# Work Order ID 70784

Item Name: 205 Skidtube bent detail

DRAWING NO. D2580	TITLE 205 SKIDTUBE ASSEMBLY	REV. D	DART AEROSPACE LTD ENGINEERING ORDER		D.E.O. NO. D2580-D-1	SHEET NO. SHEET 1 OF 1	SCALE NTS
DRAWN <i>UP</i>	CHECKED <i>L</i>	MFG. APPR. <i>E</i>	APPROVED <i>MP</i>		DE APPR. <i>MP</i>		
DATE 10.09.22	DATE 10.11.04	DATE 10.11.04	DATE 10/11/04		DATE 10.11.04

**PURPOSE:**

SECTION D-D & SECTION H-H ARE AMENDED AS FOLLOWS:

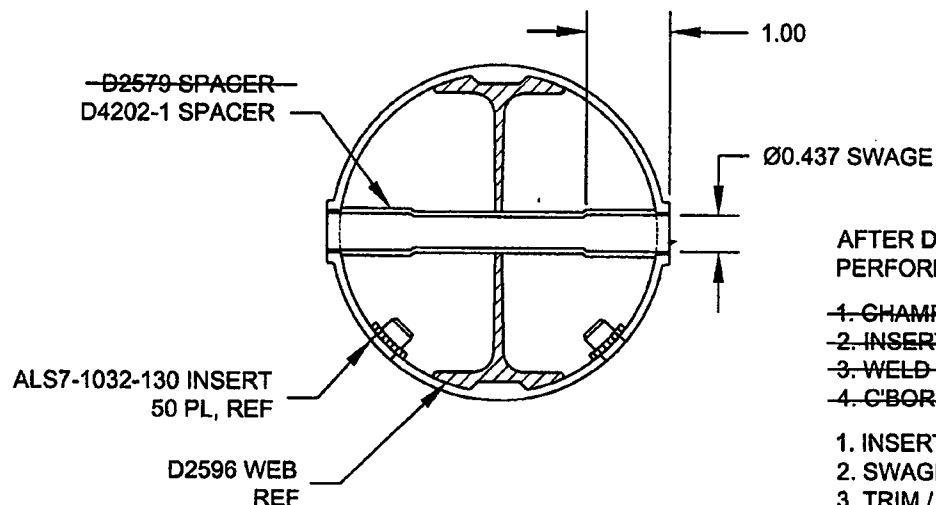
CHANGE ALL WELDED CROSSBOLT SPACERS TO SWAGED SPACERS

WAS

QTY	QTY	PART NUMBER	DESCRIPTION
-041	-045		
20	24	D2579	CROSS BOLT SPACER

AFTER DRILLING AND BENDING ASSEMBLY  
PERFORM THE FOLLOWING FOR Ø0.508 HOLES ONLY:

1. CHAMFER HOLE 0.050 X 45°
2. INSERT D2579 SPACER (20 PLACES)
3. WELD INTO PLACE AND GRIND FLUSH
4. C'BORE D2579 SPACER TO Ø0.437 X 1.00 DEEP

IS

20	24	D4202-1	SPACER
----	----	---------	--------

1. INSERT D4202-1 SPACER, 20 PL (-041) OR 24 PL (-045)
2. SWAGE TO Ø0.437 X 1.00 DEEP PER QSI 002
3. TRIM / GRIND FLUSH PER QSI 002
